SERIAL EFFECTIVITY MIC 704, S/N 758, 759, 771, 801 and upwards	EQUIPMENT AFFECTED RC700 RC702/MIC 704 Micro Processor
--	---

FIELD CHANGE ORDER

NO. 19-014

Pin No's of Pos 110

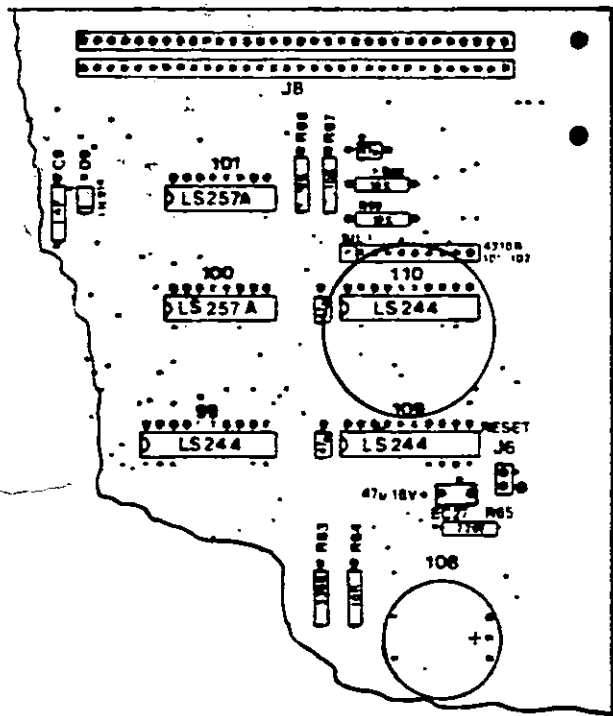
1. Insert the 5 resistors as shown on next page.
2. Fill in the FCO label 19-014.

Max height over board is 12 mm, which allows the use of Winchester adaptor.
